RE: Tin Can Alley
6100 Alameda NE
Grading & Drainage Plan and Drainage Report
Engineer's Stamp Date: 05/15/19
Hydrology File: C18D086

Based upon the information provided in your resubmittal received 05/15/2019, the Grading & Drainage Plan and Drainage Report are approved for Building Permit and Grading Permit.

**Drainage Report
For**

**Alameda & San Pedro Mixed Use
Tin Can Alley**

Overall Grading
Plan
date:
5-15-19
sheet:
c100

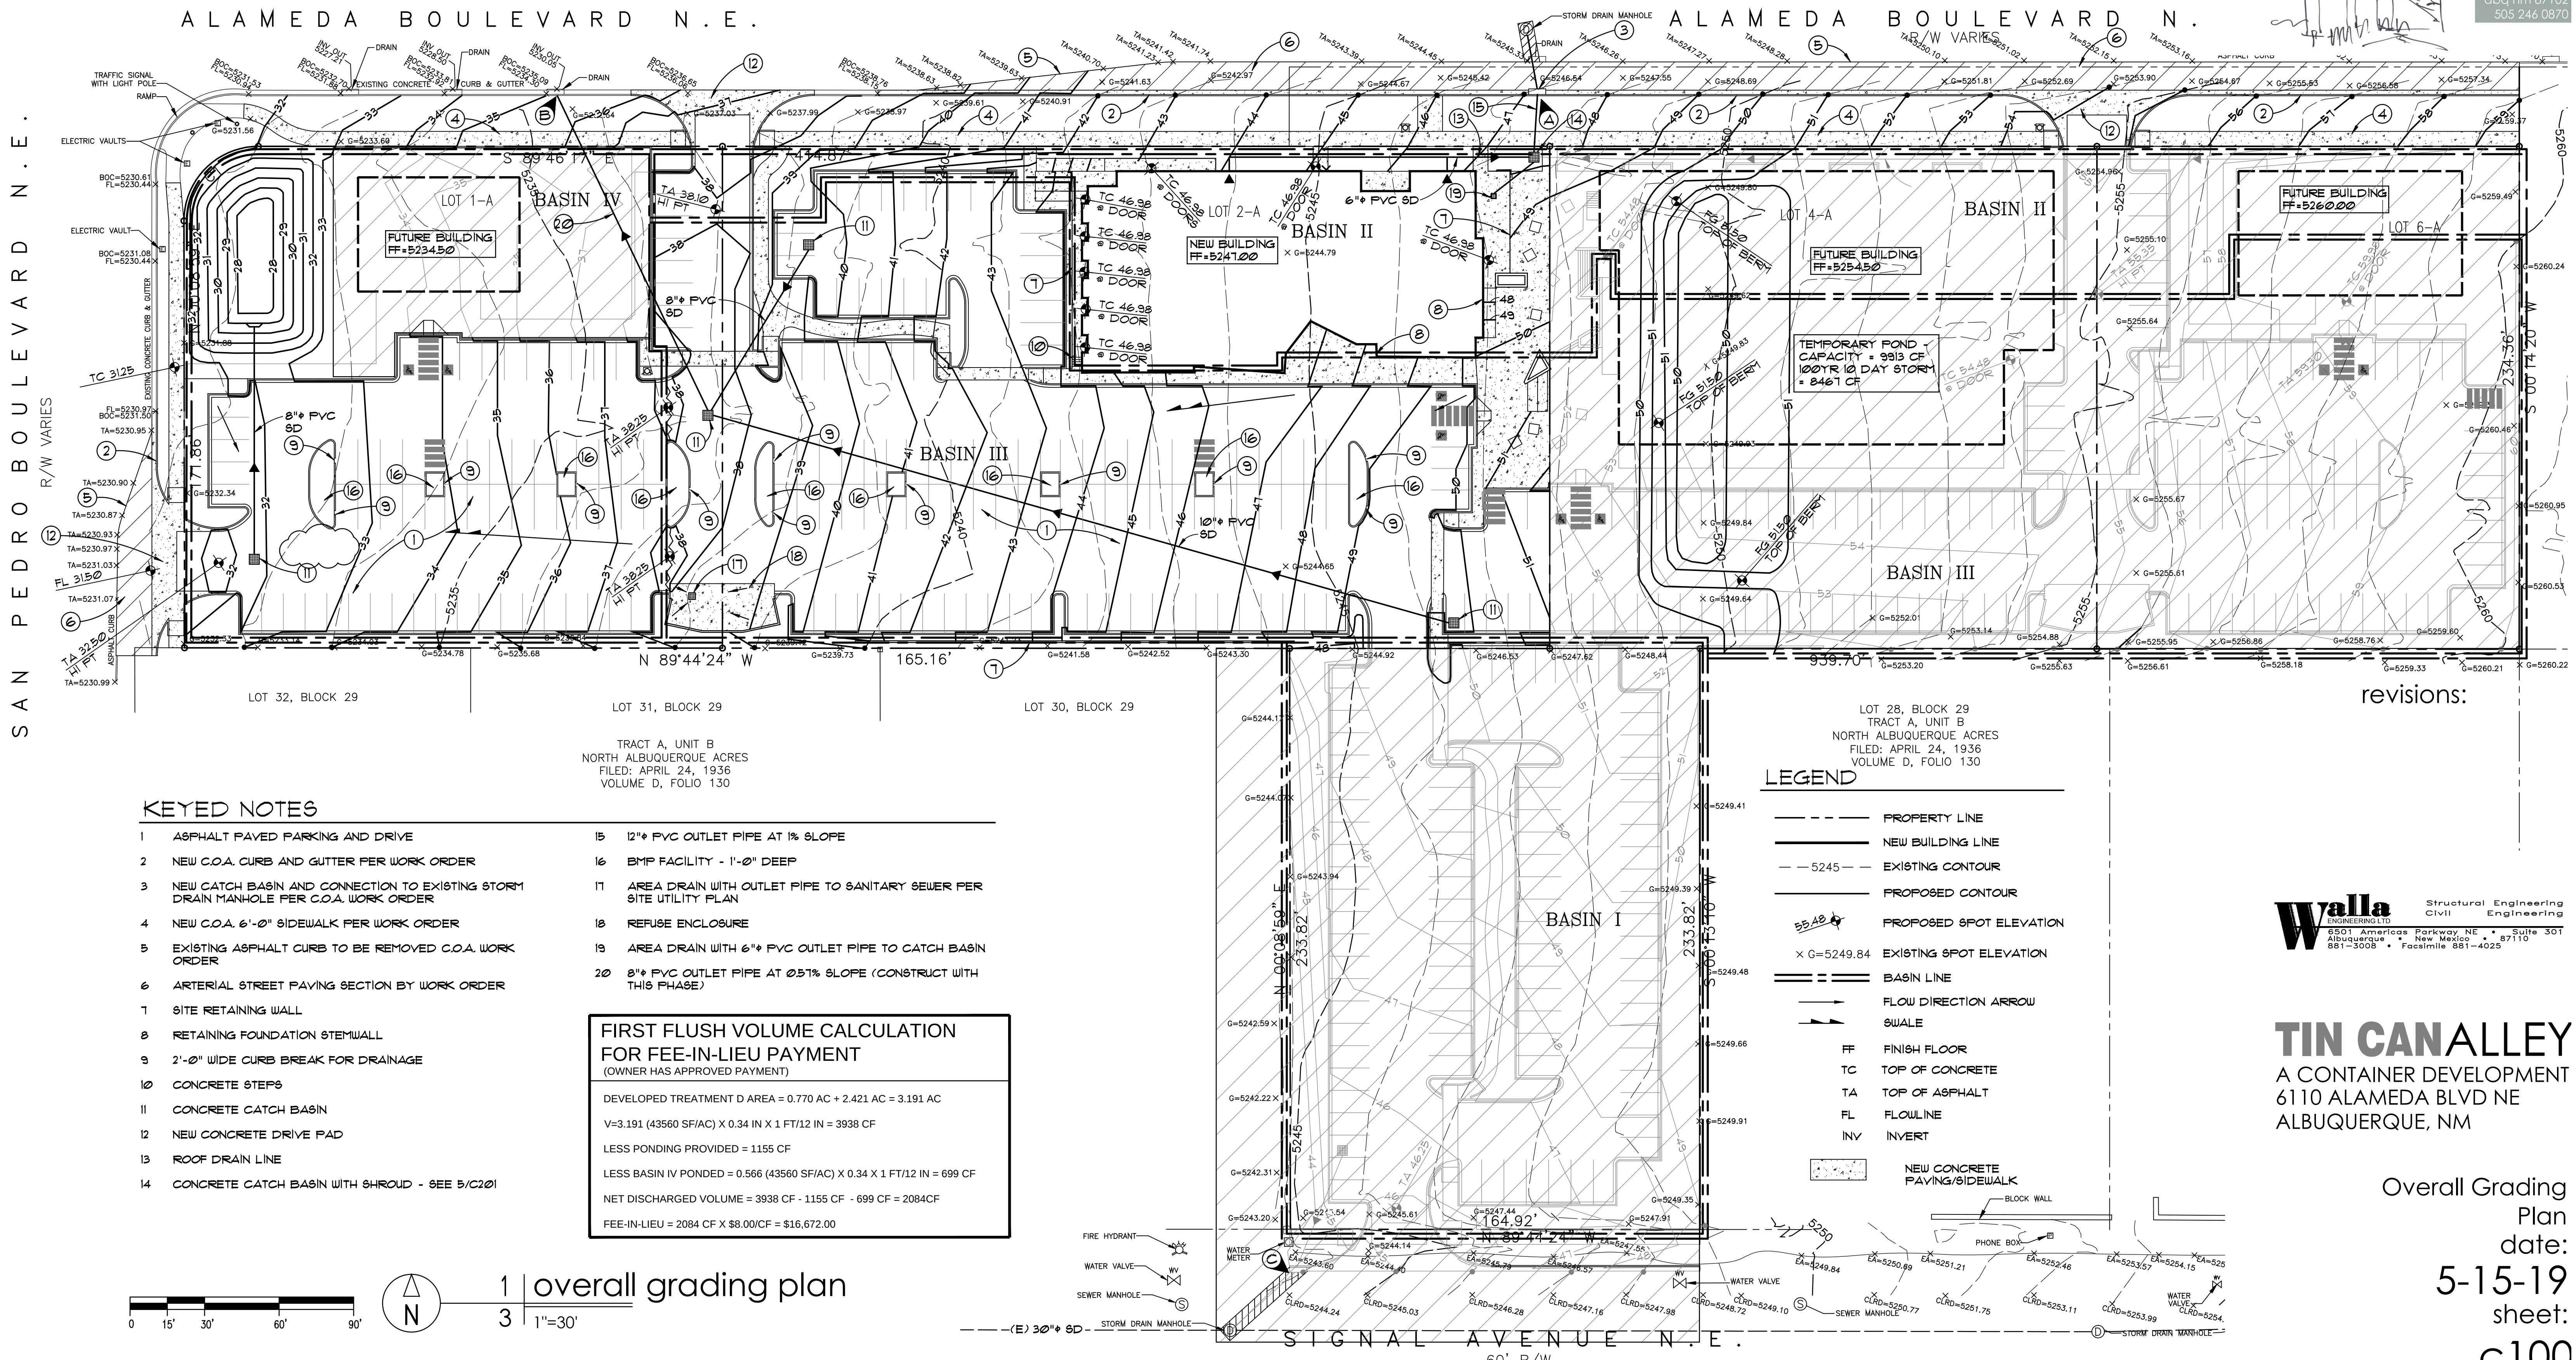
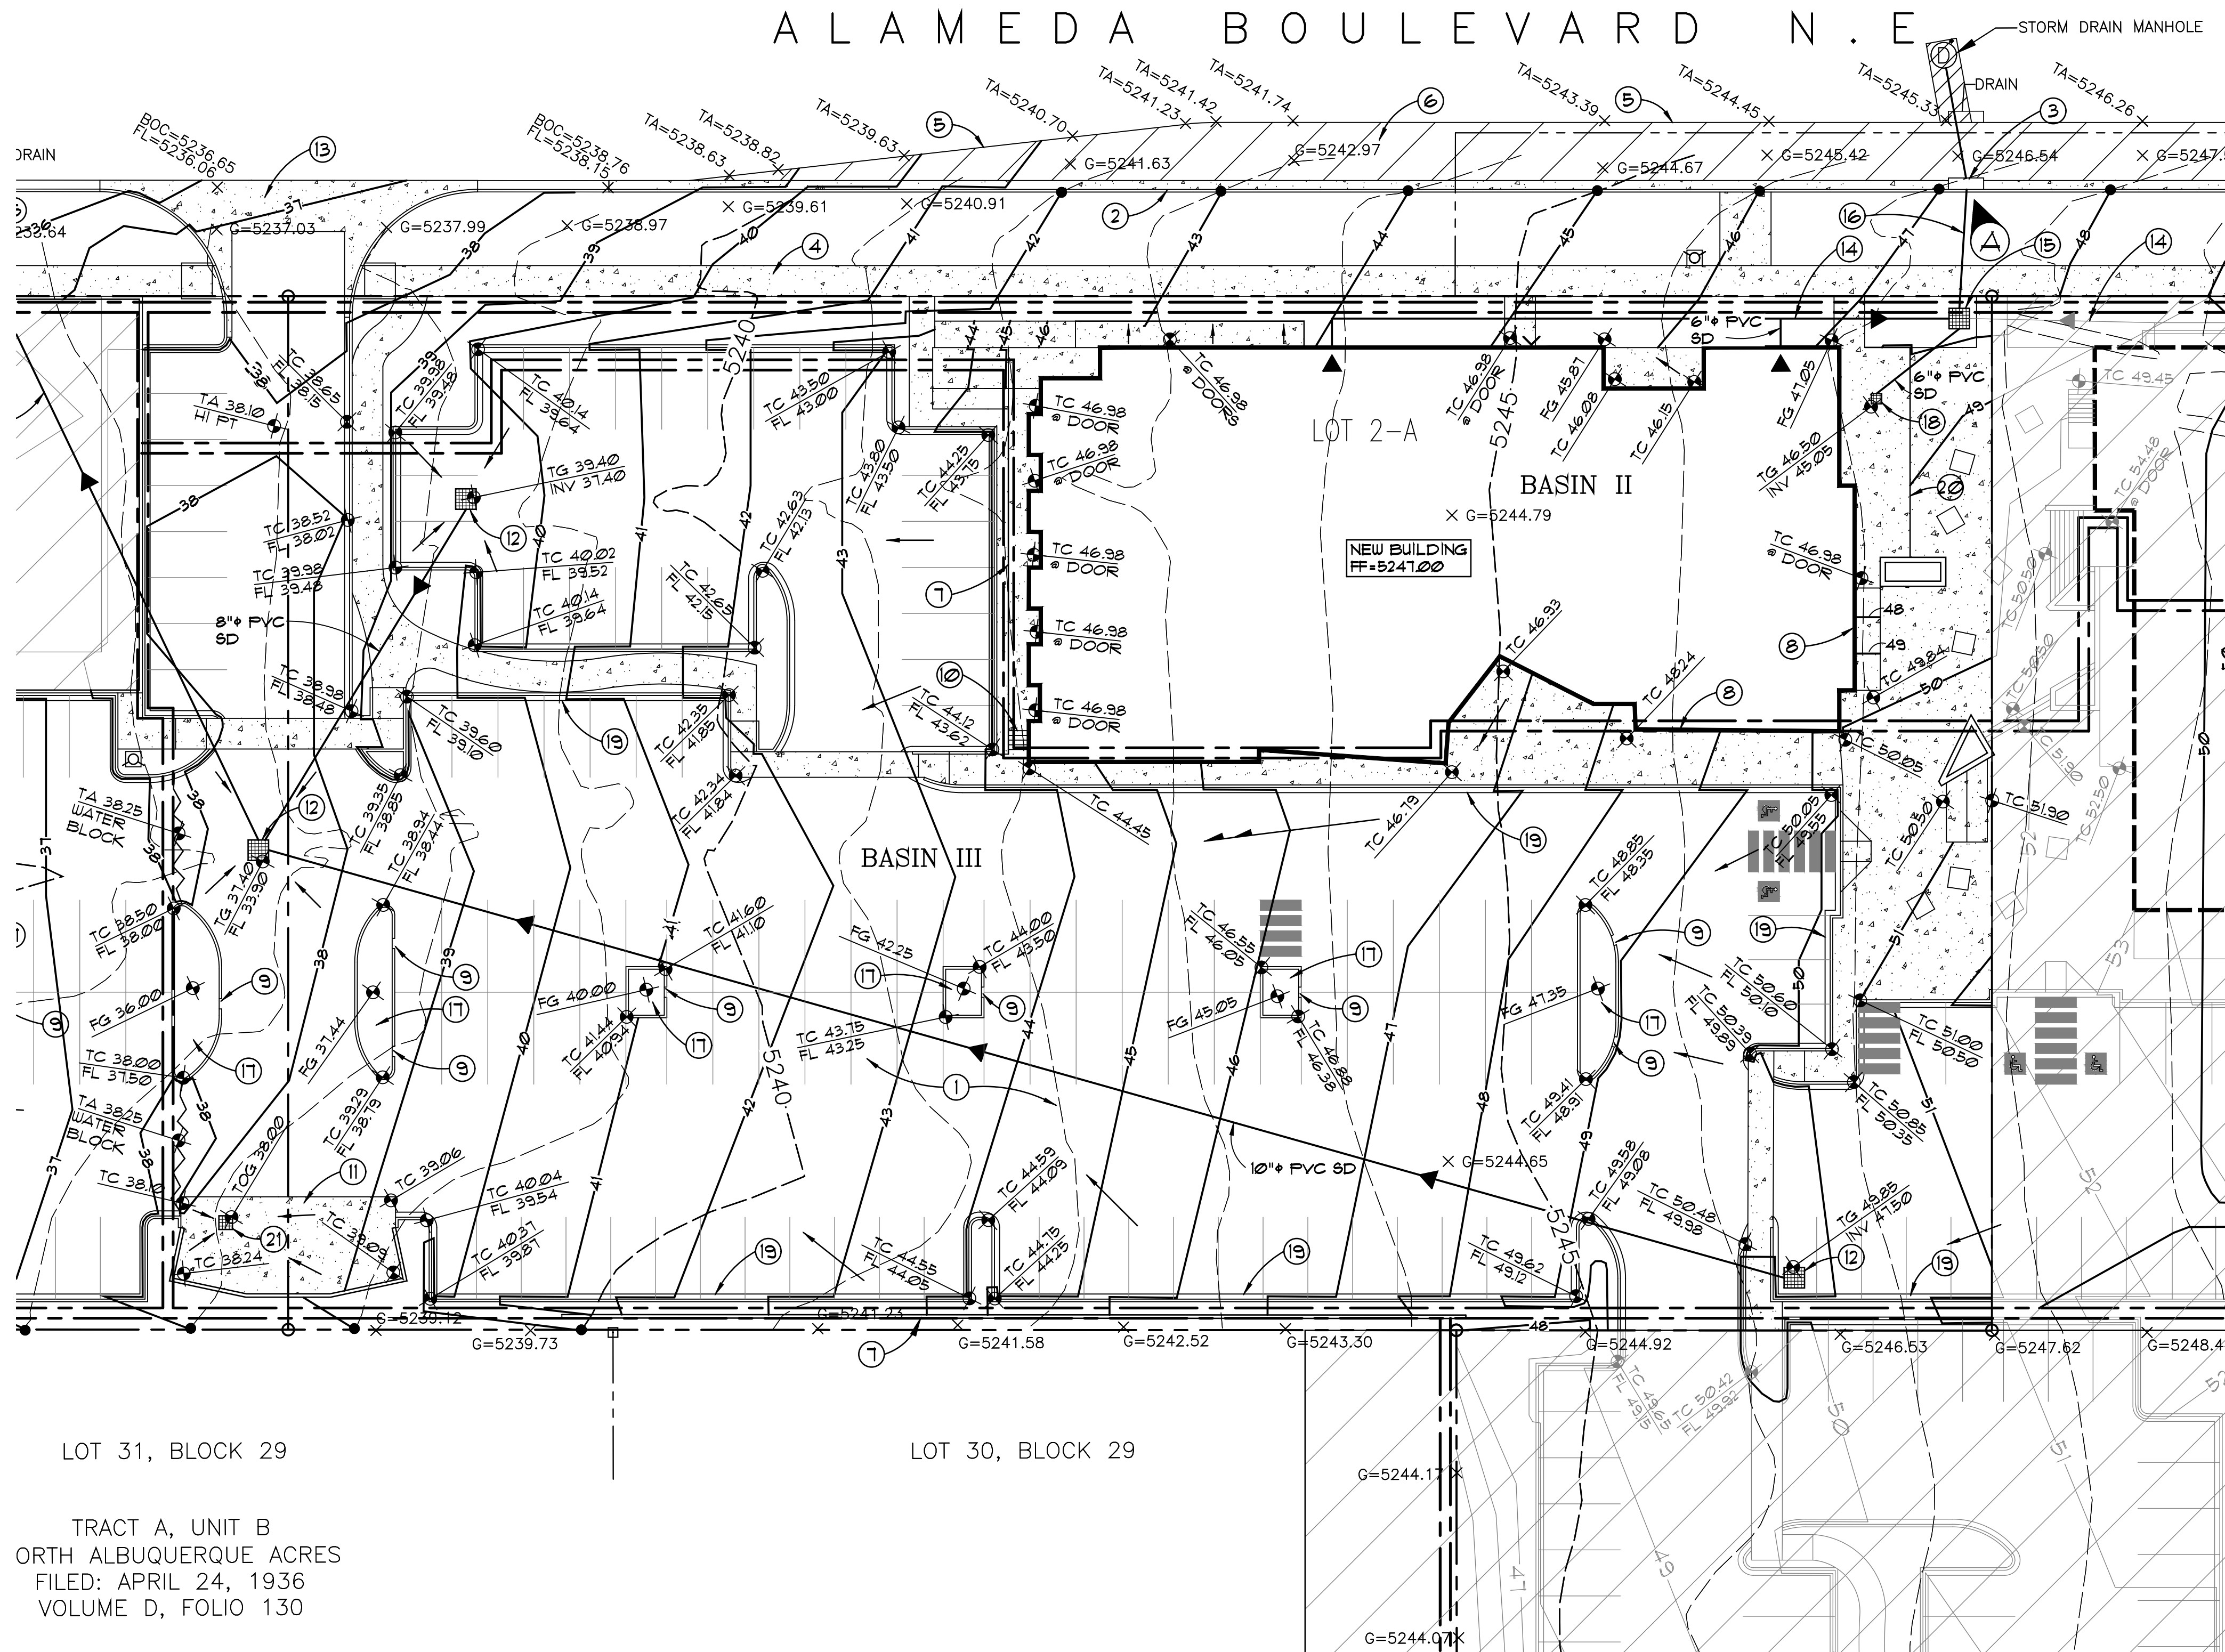
1. The HGL in the manhole in Alameda is 5231.1. Starting here and traveling through the proposed storm system, the HGL at the inlet (note 15) is 35.37 and rim of 35.75. This means that the proposed underground detention and all downstream storm sewer will not be able to discharge into the storm system and will easily go over the waterblock of 32.50 at San Pedro. Therefore, we propose two solutions.

- a. Do a complete study for the installation of inlet(s) on San Pedro along with the upsizing of the existing 48-inch pipe to probably a 60-inch and a manhole. This infrastructure will have to go back to the DRB for a revised Infrastructure List approval. This option seems to be costly and more time consuming so I suggest the second option.

- b. This option eliminates the underground detention facility and installs instead a retention pond along San Pedro for the ultimate development. The total allowable discharge to Alameda is $3.82 \text{ cfs/ac} \times 4.345 \text{ ac} = 16.59 \text{ cfs}$. Basin II is free discharge of 4.37 cfs and a remainder allowable discharge of 12.22 cfs. Basin III & IV have a 100 yr – 6 hr runoff of 15.9 cfs. 15.9 minus 12.2 leaves 3.7 cfs for retention. We will allow for the 100 yr – 6 hr volume to be used instead of the 10 day. So using the DPM, the area for retention is $3.7 \text{ cfs} / 4.49 \text{ cfs/ac} = 0.82 \text{ ac}$. The volume of retention is therefore $2.58'' \text{ (excess type D)} \times 0.82 \text{ ac} = 7,717 \text{ cf}$. Therefore a pond 20' x 80' x 5' (depth) will provide a volume of 8,000 cf. This

pond will be walled with a security fence around it so no one falls in. A waterblock will need to be created at the curb return just to the east of the proposed underground detention. (Location provided on plans) Basin III will stop at this waterblock and Basin IV will extend to the south. Not only does the underground detention facility be eliminated, but two additional inlets and pipes are eliminated as well. (Marked on the plans) The inlet just to the east of the new waterblock, needs to be lowered a bit. This maybe lowered to say TG 37.50. (Please check to ensure that this is enough so that the runoff does not just go over the new waterblock) From this inlet, the outflow pipe can then connect to the most easterly of the existing three inlets. This pipe should be able to discharge the allowable 12.22 cfs. The only other new pipe is from the inlet by the San Pedro entrance and goes to the retention pond. This option also has the benefit of lowering the elected Payment-in-Lieu amount. Please verify the correct amount. By my calculation, for 0.82 ac @ 90% impervious will need a stormwater quality volume of 910 cf. Since this will be handled within the required retention pond volume it can be subtracted from the site's deficit volume amount. The total site stormwater quality volume is 3655 cf – 1155 cf (provided) – 910 cf (retention pond) = 1,590 cf. The Payment-in-Lieu amount is 1590 cf * \$8/cf = \$12,720. This is a savings of \$7,280. Along with the savings of the revised storm sewer system, this is a better option than the first one.

2. Please reflect the Grading and Drainage Plans for whichever option that you chose.
3. Please reflect the Drainage Report for whichever option that you chose.
4. Please add the calculations for the temporary retention pond to the Drainage Report.

1. Following your recommendations we have eliminated the underground storage facility for storm water runoff and have designed a Retention Pond that will hold runoff from the western end of the Alameda Mixed Use project. The drainage basins have been revised to account for this change as have the runoff calculations for the affected basins.
2. Grading and Drainage Plans for project have been modified to reflect the recommended changes.
3. The Drainage Report has been revised to reflect the design changes recommended.
4. Temporary pond volume calculations have been added to the Drainage Report and slight modifications to this pond are reflected on the drawing.

Separate Drainage Covenants will be provided for both the Temporary Pond and the permanent onsite drainage improvements. These are in process now and will be recorded prior to submittal for a Certificate of Occupancy on the project. The Fee-in-lieu calculation is included on the plan and was adjusted based on revised discharge quantities.
